**From:** [Amy Snyder](#)  
**To:** [Amy C. Hazelhoff](#)  
**Cc:** [Shaun Anderson](#); [Greg Chapman](#); [Karen Pinkston](#); [Louis Caponi \(He/Him\)](#); [David Hills](#); [Bill Lin](#)  
**Subject:** Zion Confirmatory Survey Extent of Condition  
**Date:** Friday, August 11, 2023 11:18:00 AM  
**Attachments:** [FINAL\\_Summer-converted\\_using\\_Microsoft\\_print\\_PDF.pdf](#)  
[image001.png](#)

Based on the risk-informed survey evaluation criteria developed prior to the 2023 Zion Confirmatory Survey (ML23221A243, attached), NRC staff have assessed the factors discussed using the available confirmatory surface data and other information. One concern that staff currently have is that whether detectable particles may still be present in portions of the site that were not scanned at 100% with discrete radioactive particles (DRP) data quality objectives (DQOs), particularly at or near the Southeastern portion of the site.

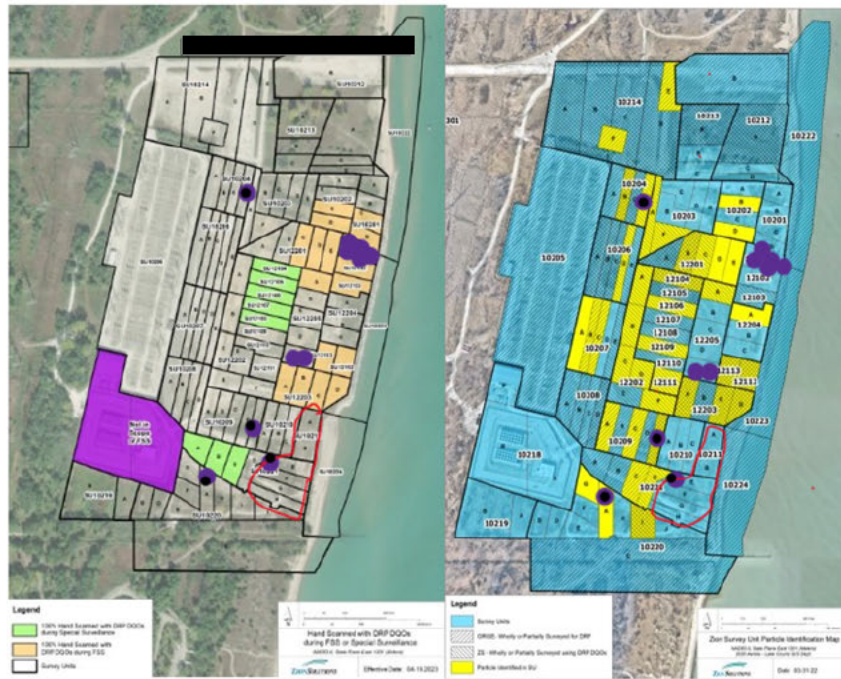
- the pattern of DRPs and activated material found and removed since 2020
- the results of the 2023 Zion Confirmatory Survey at or near the South portion of the property surrounding several survey units that were not hand scanned using the ZS Survey Plan DQOs or included in the scope of the confirmatory surveys (SU 10221 and 10211) (See maps below) and
- the past rail waste loading activities that occurred at the south end of the site

an evaluation of extent of condition for the Southeastern portion of the site is needed consistent with the ZS Confirmatory Survey Criteria (see page 11, column 3 of the ZS Confirmatory Survey Criteria attached).

One approach for the evaluation of the extent of condition that would be acceptable to the NRC: To ensure that cross contamination of DRPs in SU 10221 and 10211 did not occur as a result of rail loading of waste at or near the south rail loading area, hand scanning SUs 10221 E,F,G,& H and 10211 A&B at 100% coverage to ensure that there are no gaps in the extent of condition to identify and remove DRPs could be done.

Green and orange areas: hand-scanned with DRP DQOs

Yellow areas: DRPs found either on surface or at depth (<1 ft)

We expect to get the last remaining DRP sample results back next week sometime and will evaluate those to determine if they are DRPs of concern with respect to dose. The DRPs which we do not have gamma scan results back yet **are identified on the map** as purple dots with black circles in them (SU 10209D, SU10221E, SU1022A, and SU10204D) and were considered by staff in the pattern of DPRs found since 2020. Also, soil sample results for radionuclides of concern (ROCs) are expected back by the end of August. We will evaluate the data once they are received.
